To: Dennis Dreeszen, Troy Kirschman
From: Chris LaRue, Senior Planner
Date: January 27, 2021
Re: SP-001187-2020: Vista Ridge Filing No. 6, 2nd Amendment, Lot 5 – Vista Ridge Auto Wash
SRU-001186-2020 – Special Review Use for the Auto Wash
cc: Fred Starr; Deborah Bachelder; David Pasic; Chad Schroeder; Luke Bolinger; Darren
Champion

VISTA RIDGE FILING NO. 6, 2ND AMENDMENT, LOT 5 SITE PLAN AUTOWASH AT VISTA RIDGE

A PORTION OF THE SOUTHEAST 1/4 OF SECTION 32, TOWNSHIP 1 NORTH, RANGE 68 WEST OF THE 6TH PRINCIPAL MERIDIAN
TOWN OF ERIE, COUNTY OF WELD, STATE OF COLORADO
SRU AREA - 0.83 ACRES - TOTAL AREA 0.83 ACRES
SITE PLAN - SP-001187-2020
(SPECIAL REVIEW USE SITE PLAN - SRU-001186-2020)

COVER SHEET

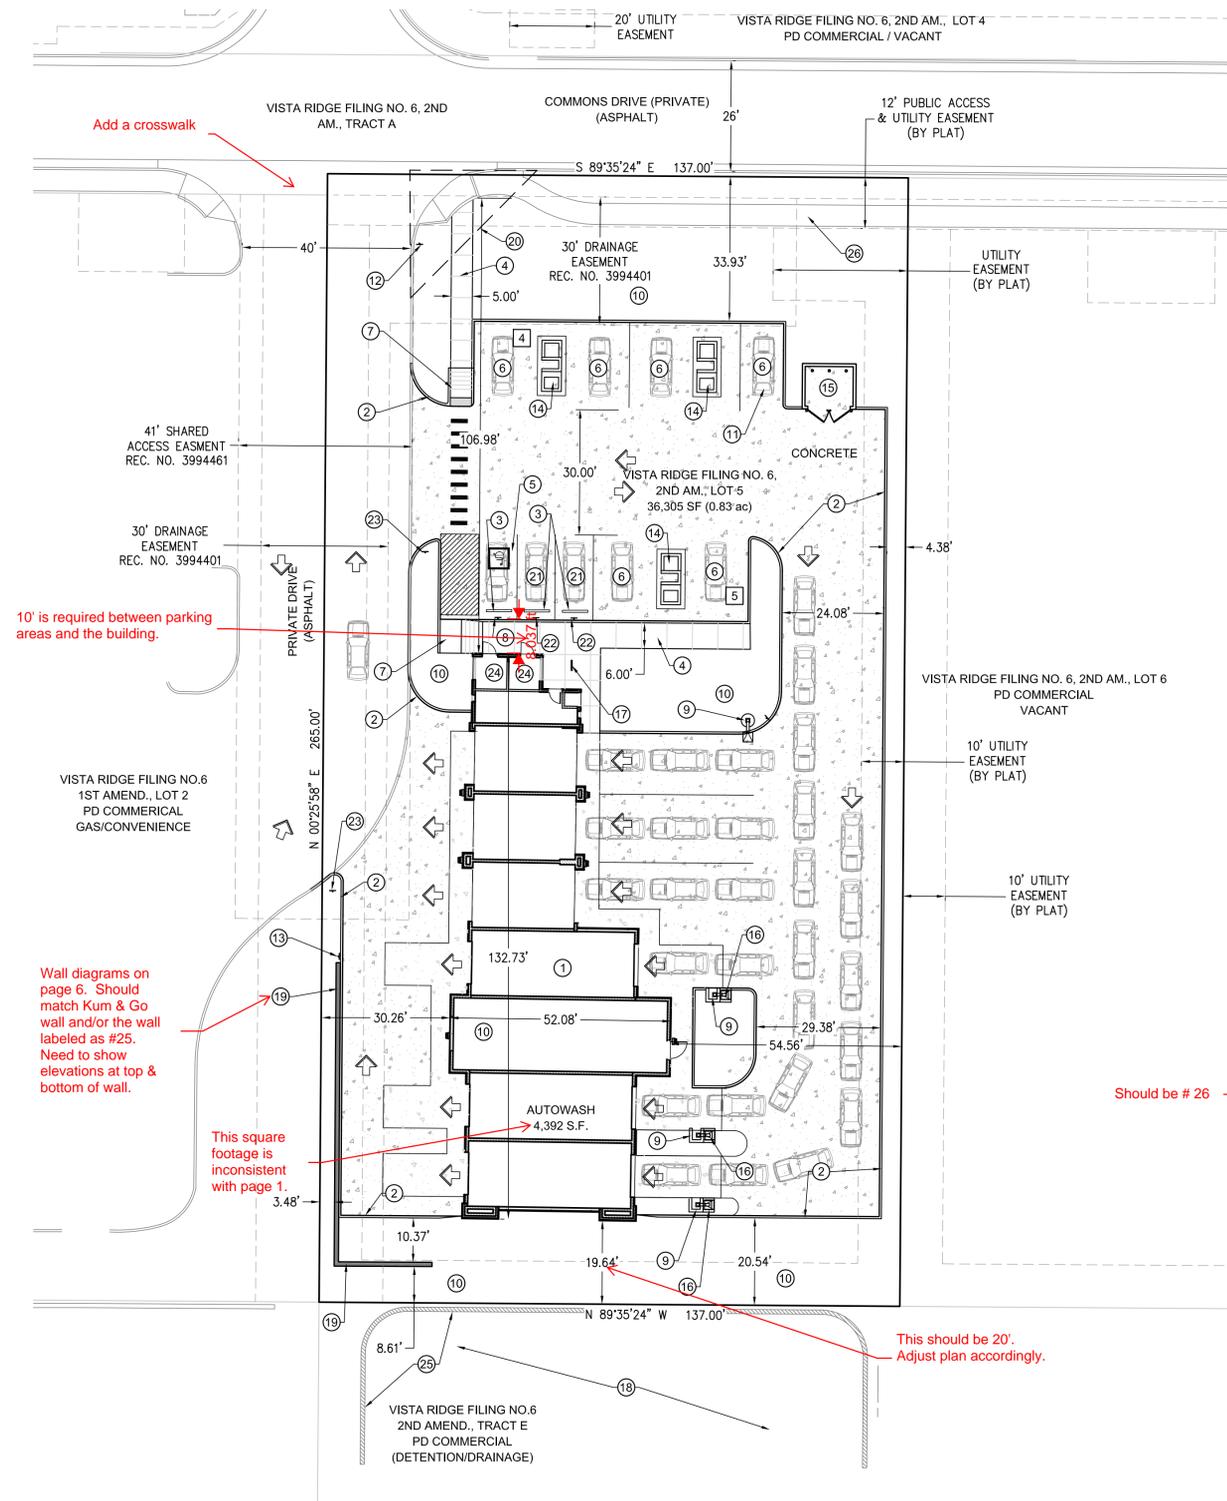
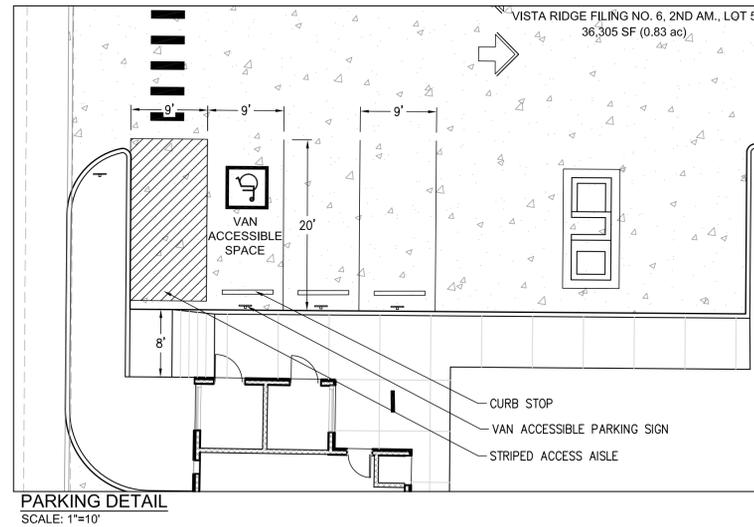
Narrative should be updated regarding the parking. It states there are 9 vacuum spaces & 2 additional spaces (11 total). There are 6 vacuum spaces, 2 pet wash spaces, & 1 handicap person space (9 total). Also remove the statements about outside storage and loading areas. A loading area is not required because the building is under 7,000 sq. ft. and outdoor storage will not be utilized.

Add Planning Commission Chair signature line. Remove Planning Director line.

LANDSCAPE PLAN

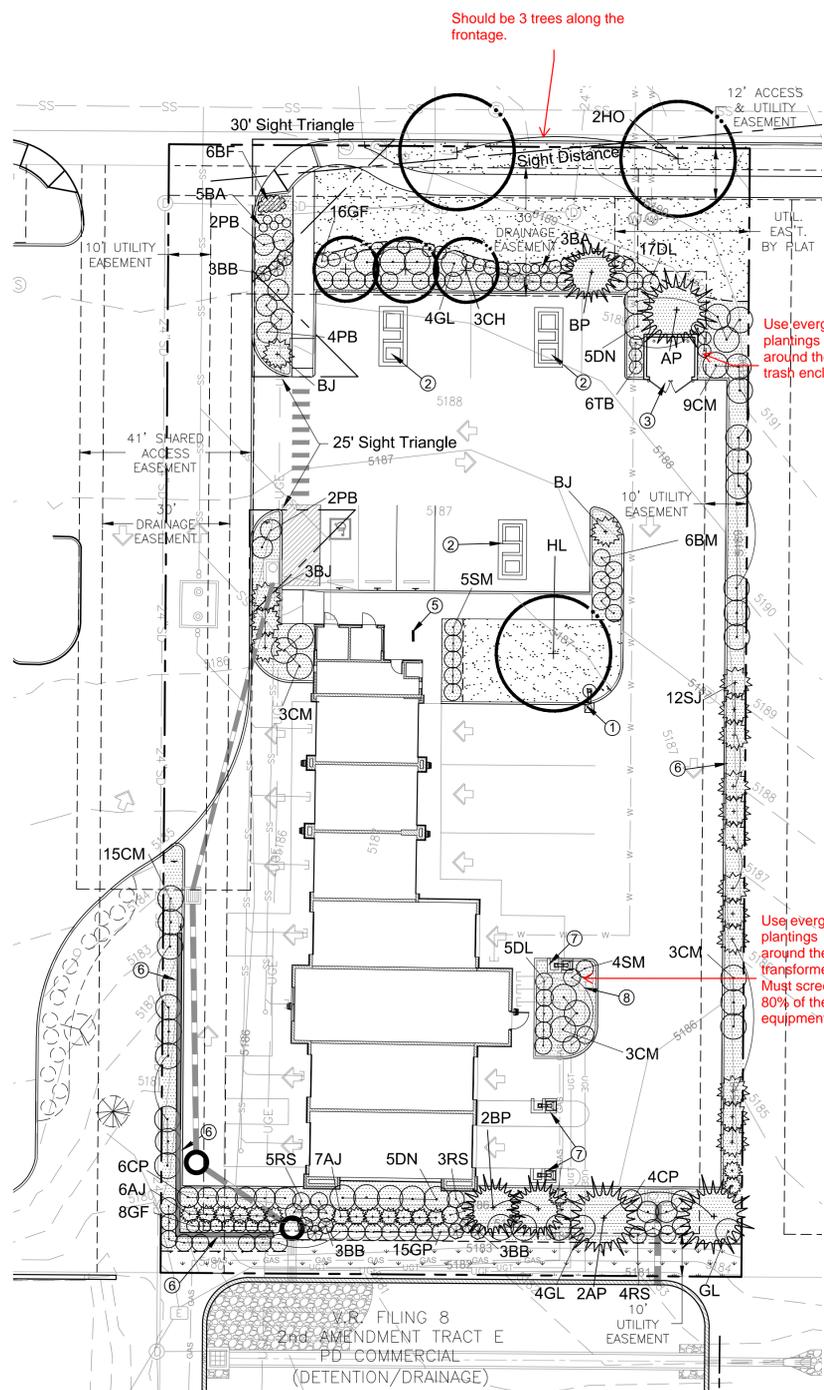
Place symbol from legend on the plan to identify the locations as well.

UTILITY PLAN

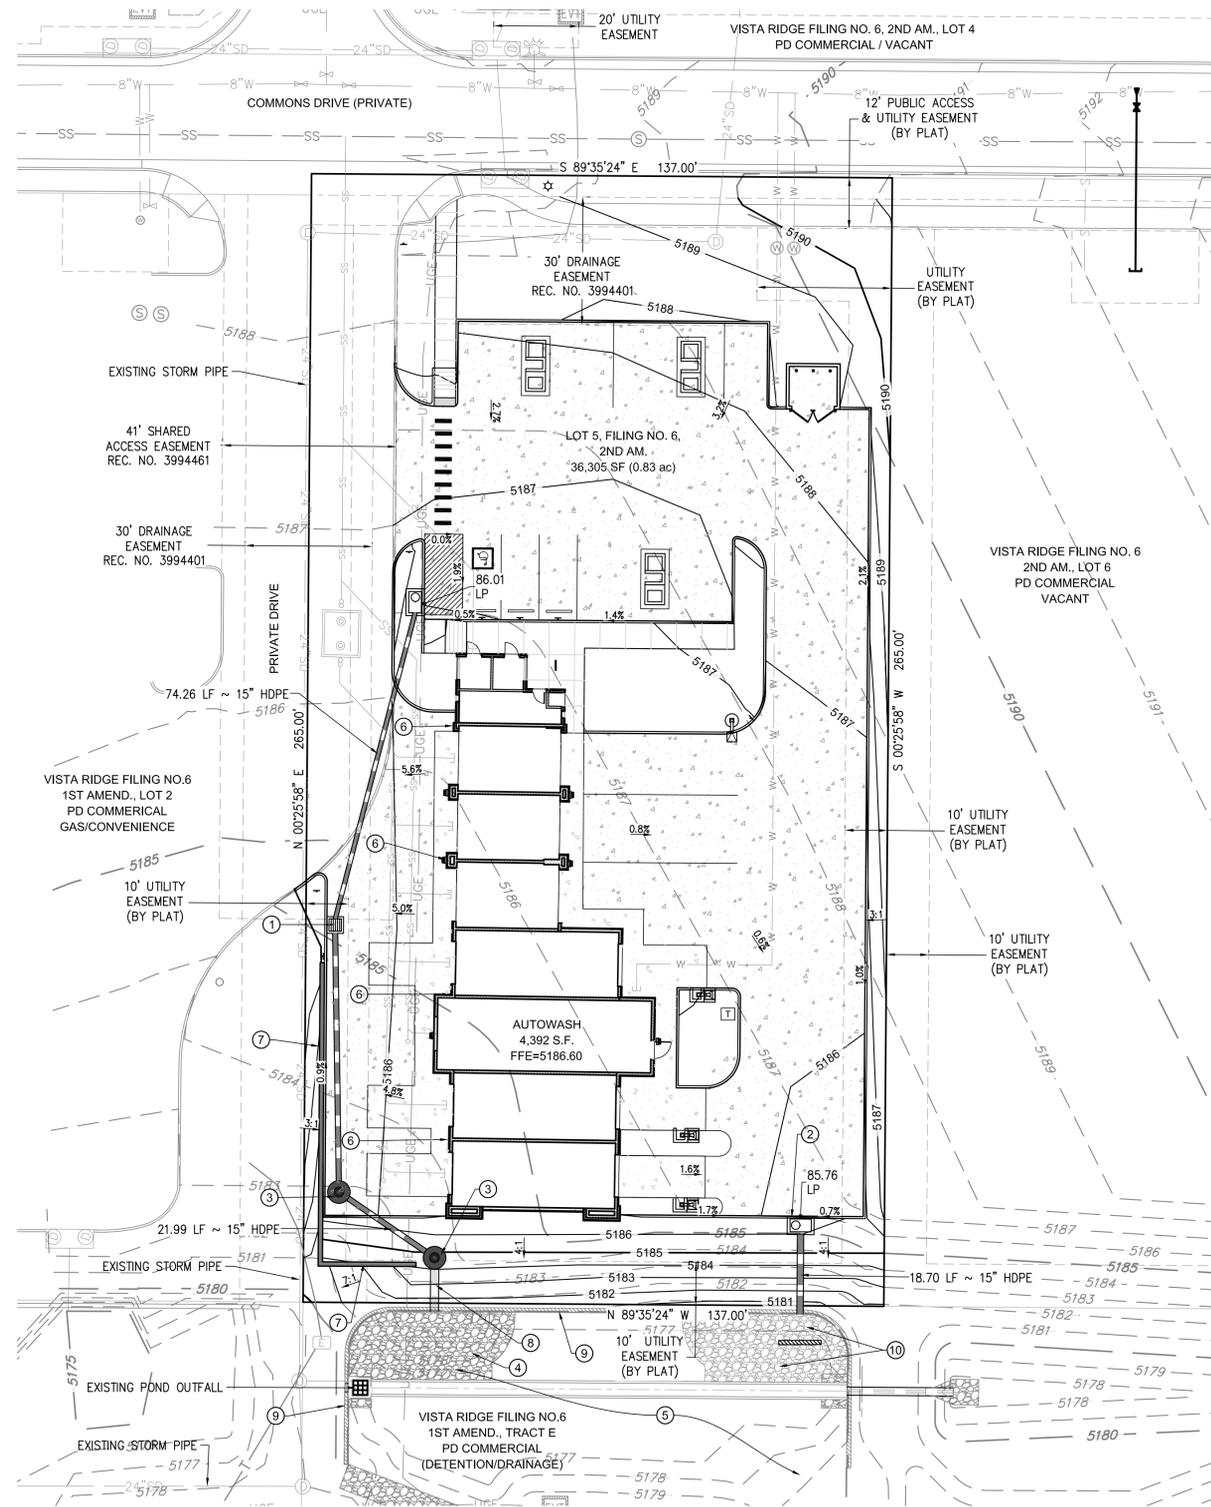
18. On Sheet 5 Utility Plan, we have the following comments:

- f. Correct Note 6 to agree with the label shown on the plan for the “15” SD (Private).”
- g. Clarify if the 18” RCP outfall pipe is existing or not. If it is existing, correct Notes 8 and 9 to indicate that the storm pipe and detention pond are existing. If it is not existing, then clarify who will be required to construct these and when, and how the timing of construction is coordinated with the development of the Autowash site (i.e., the Pond D must be constructed prior to, or consecutively with, the Autowash site).
- h. Note 5 does not indicate that two different inlet types are proposed. Use labels or notes to identify which inlets are Type R inlets and which are Type 13 Combination inlets.

Site Details

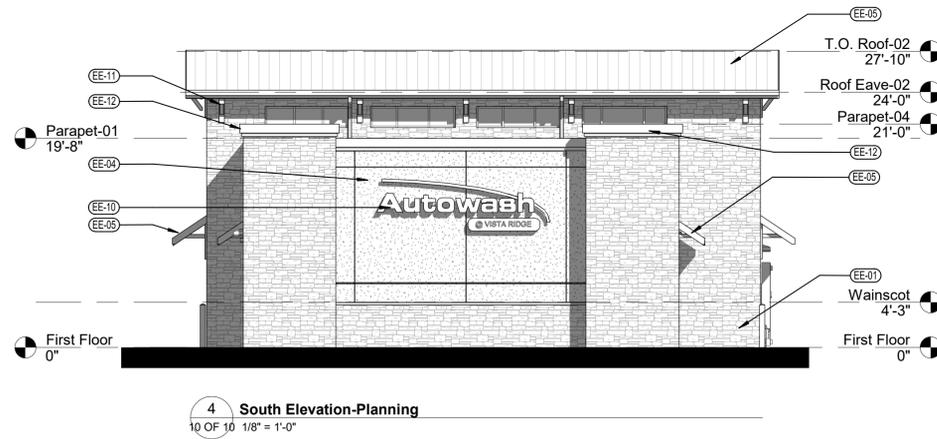
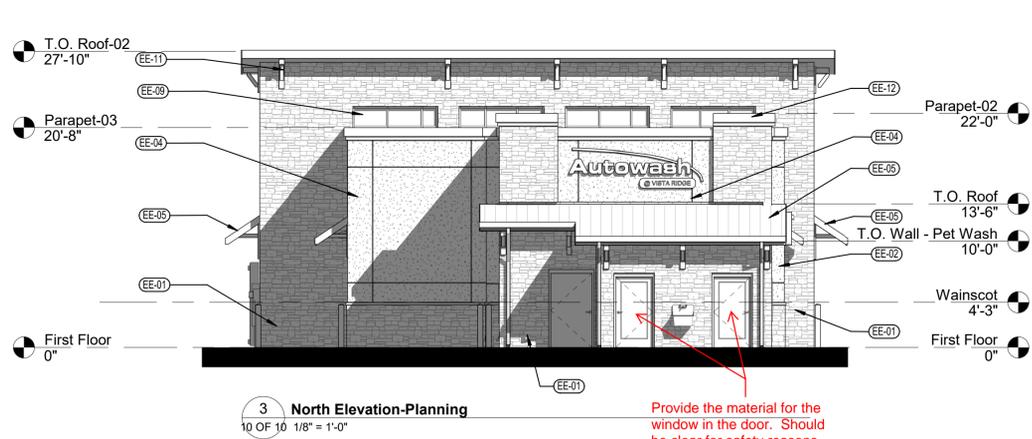
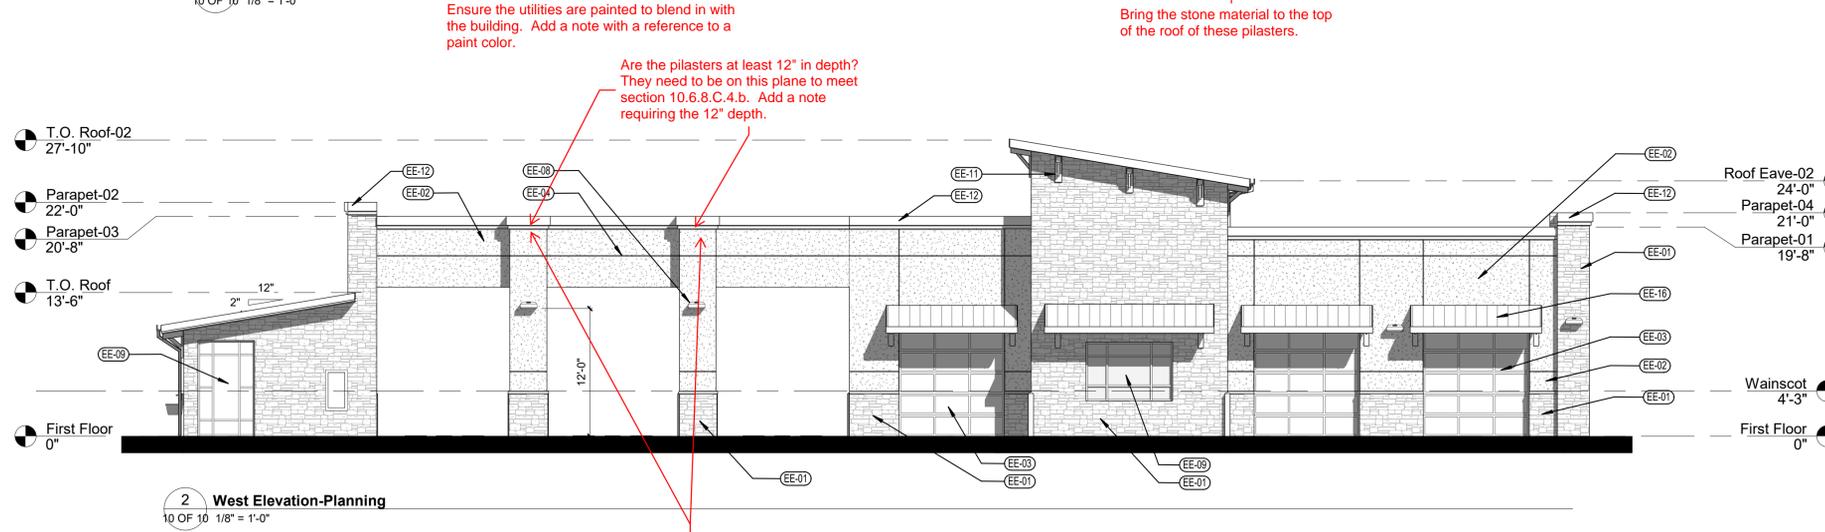
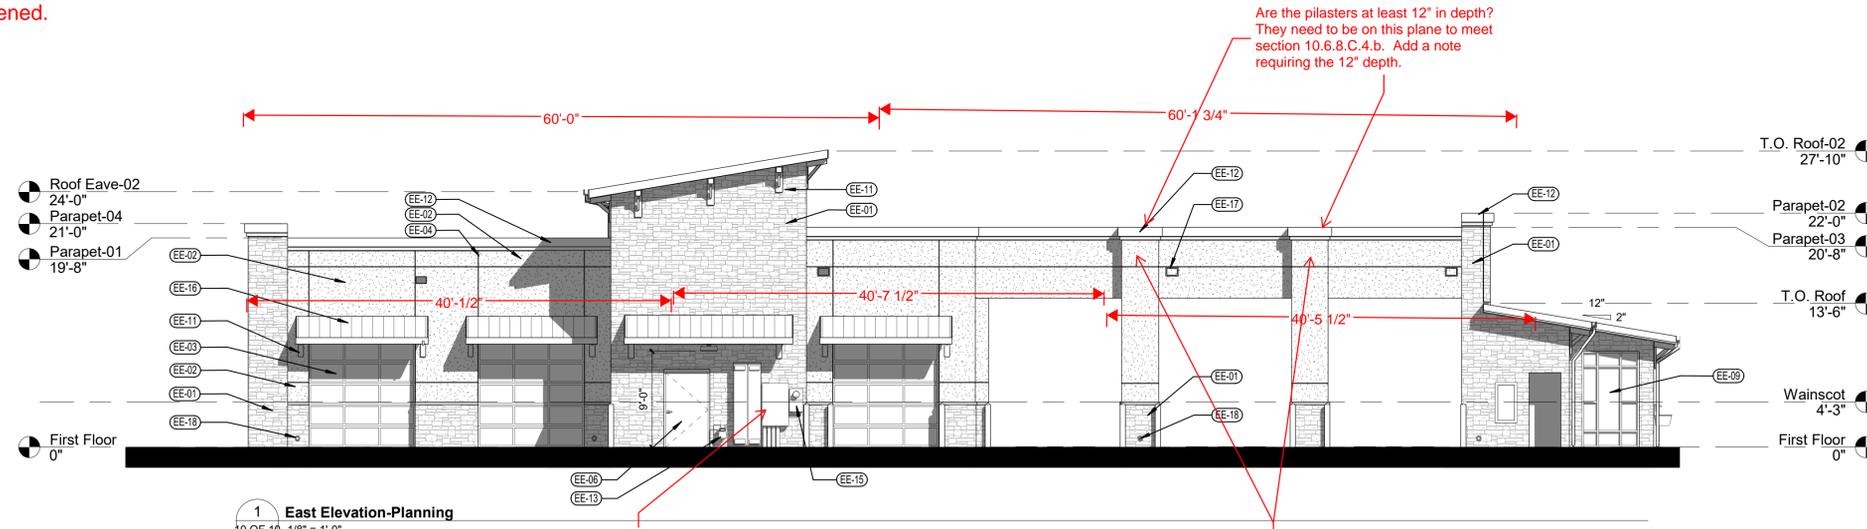
Smooth face CMU is not used on the main building. The previous site plan had this finished with stone to match the building. Update the plans to depict the stone material on the vacuum and pay stations.
